REQUEST FOR INFORMATION DATE: June 02, 2016 NO.: RFI-143

Project Name: 15051-Webster University Interdisciplinary Science Building Project No.: 15051

Subject: Elevation on S0103

LEVEL 02 FLOOR
FRAMING PLAN

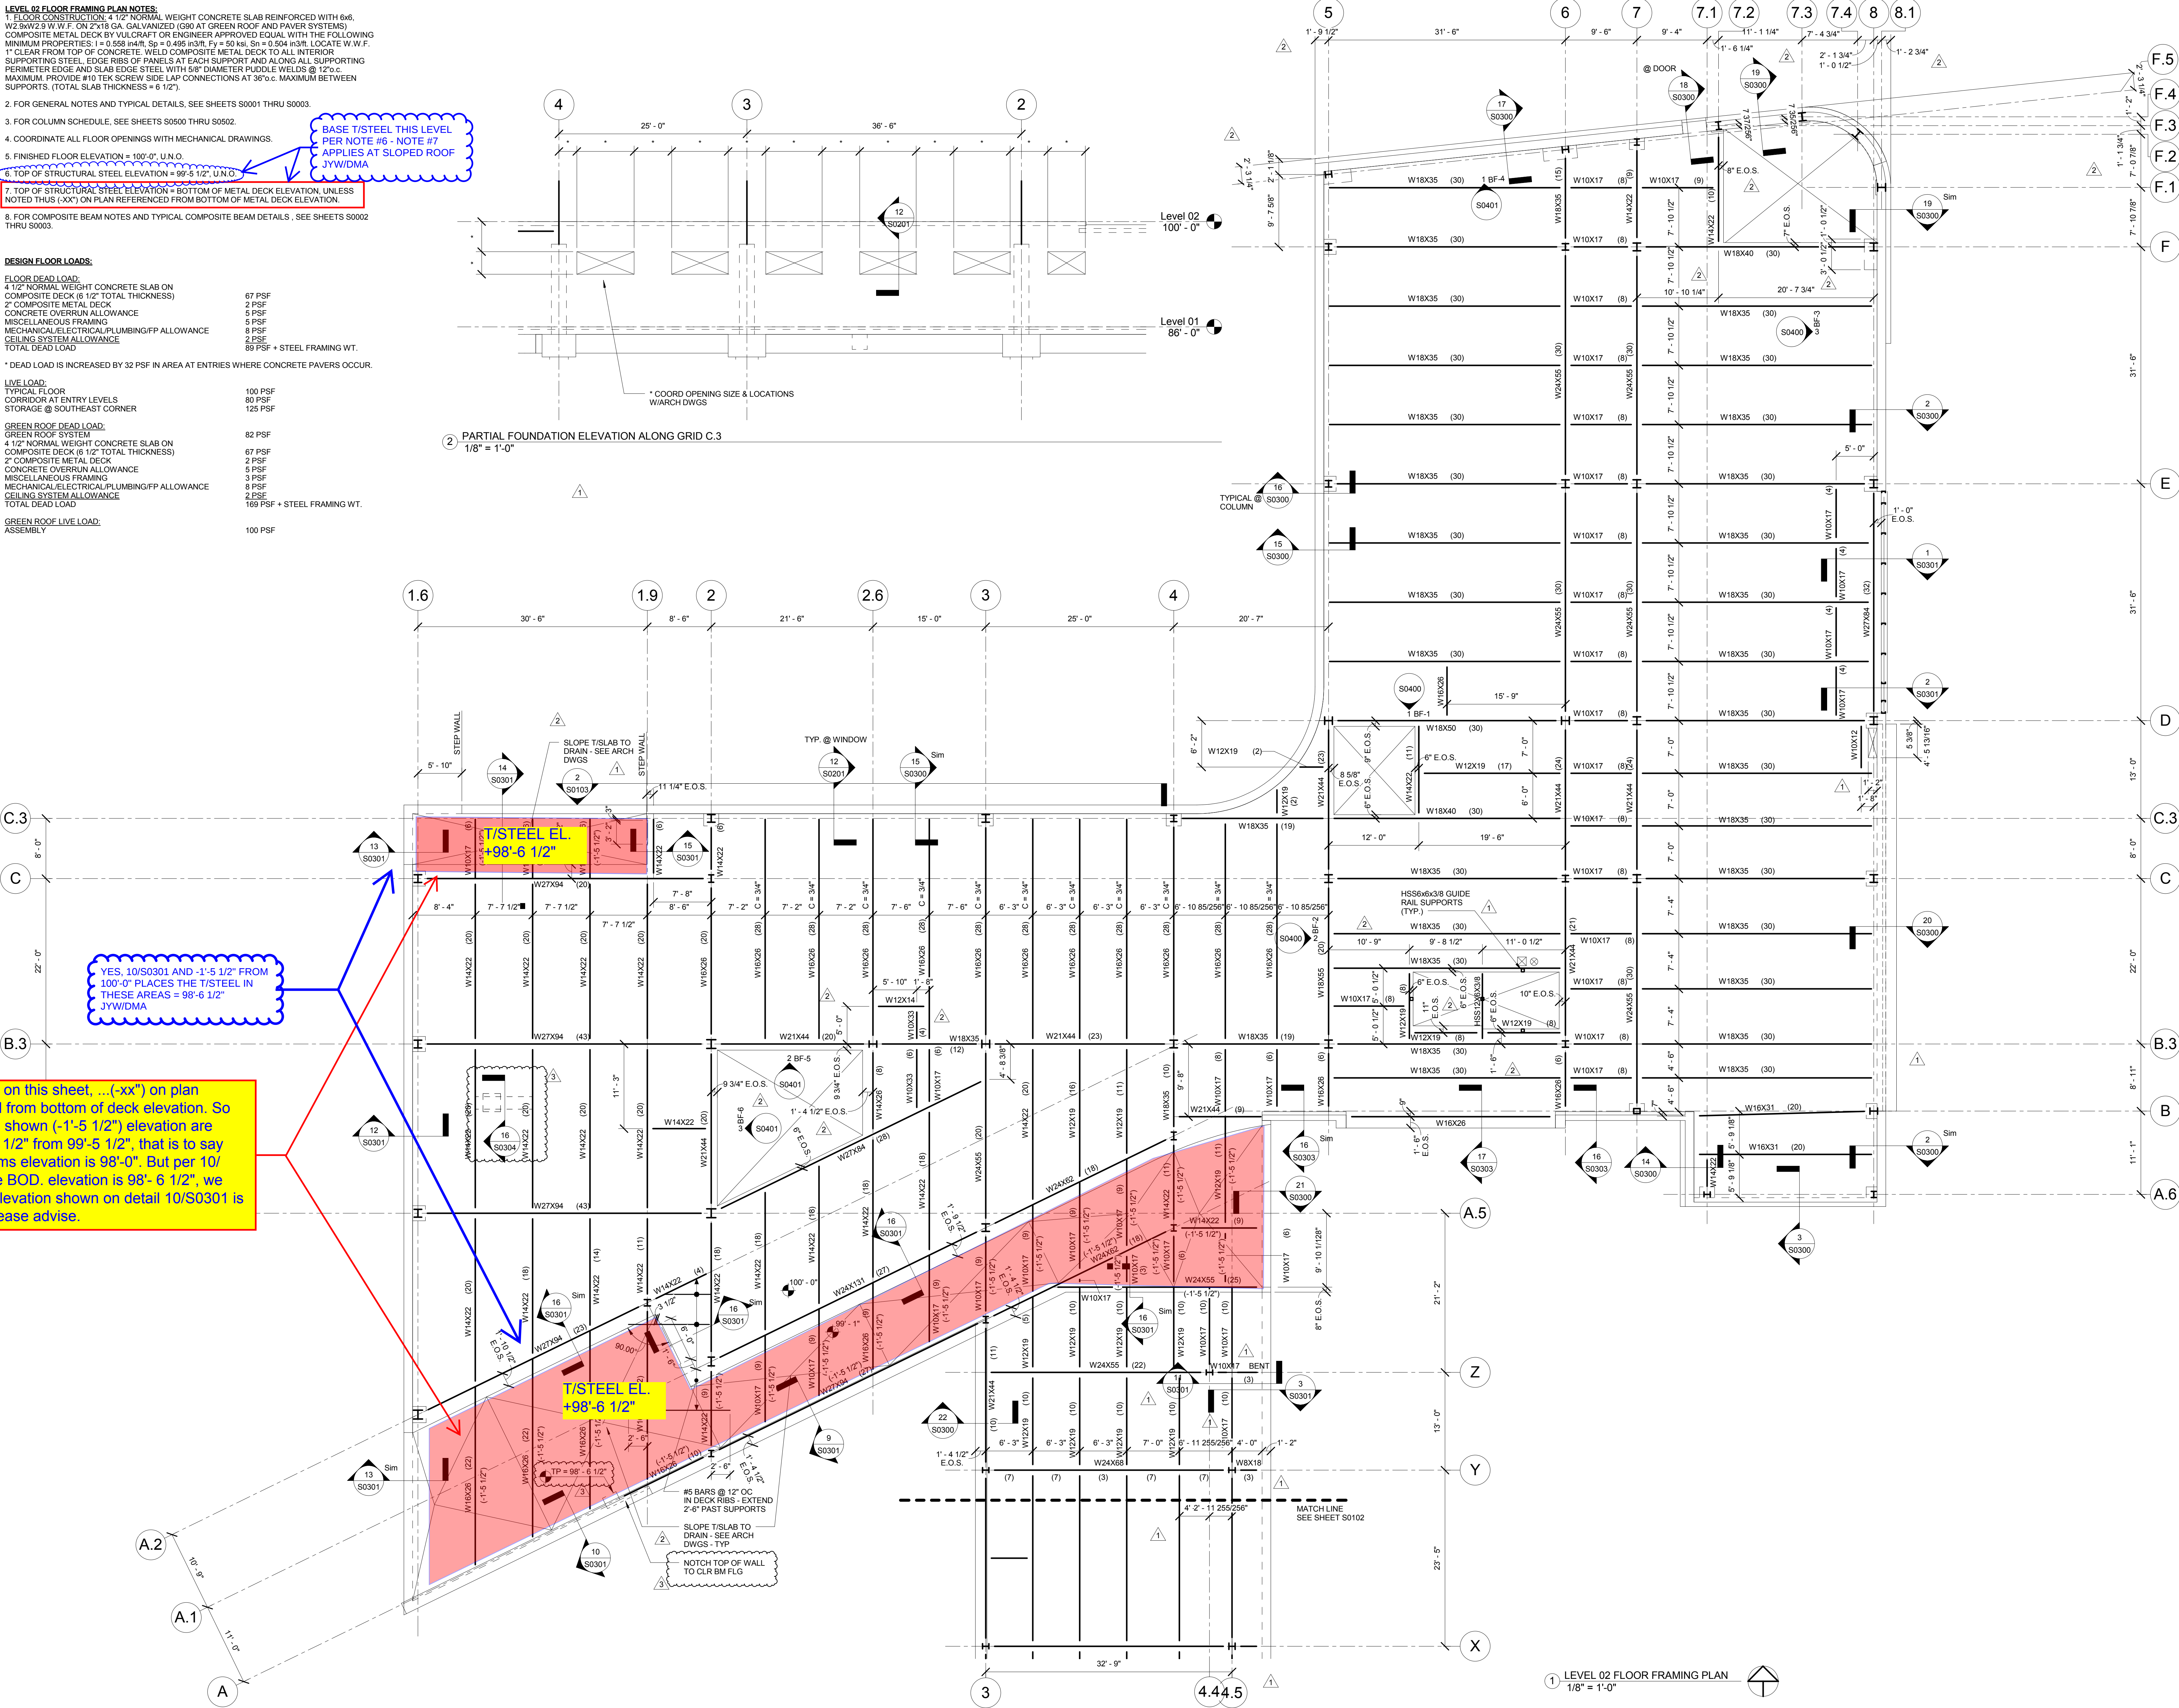
Per note 7 on S0103, ...(-xx") on plan referenced from bottom of deck elevation. So the beams shown (-1'-5 1/2") elevation are below 1'-5 1/2" from 99'-5 1/2", that is to say these beams elevation is 98'-0". But per 10/S0301, the BOD. elevation is 98'- 6 1/2", we think the elevation shown on detail 10/S0301 is correct, please advise.

Per note 7 on this sheet, ...(-xx") on plan referenced from bottom of deck elevation. So the beams shown (-1'-5 1/2") elevation are below 1'-5 1/2" from 99'-5 1/2", that is to say these beams elevation is 98'-0". But per 10/S0301, the BOD elevation is 98'-6 1/2", we think the elevation shown on detail 10/S0301 is correct, please advise.

Yes, 98'-6 1/2" is correct.

BASE T/STEEL THIS LEVEL PER NOTE #6. NOTE #7 APPLIES AT SLOPED ROOF JYWDMA

YES, 10/S0301 AND -1'-5 1/2" FROM 100'-0" PLACES THE T/STEEL IN THESE AREAS = 98'-6 1/2" JYWDMA
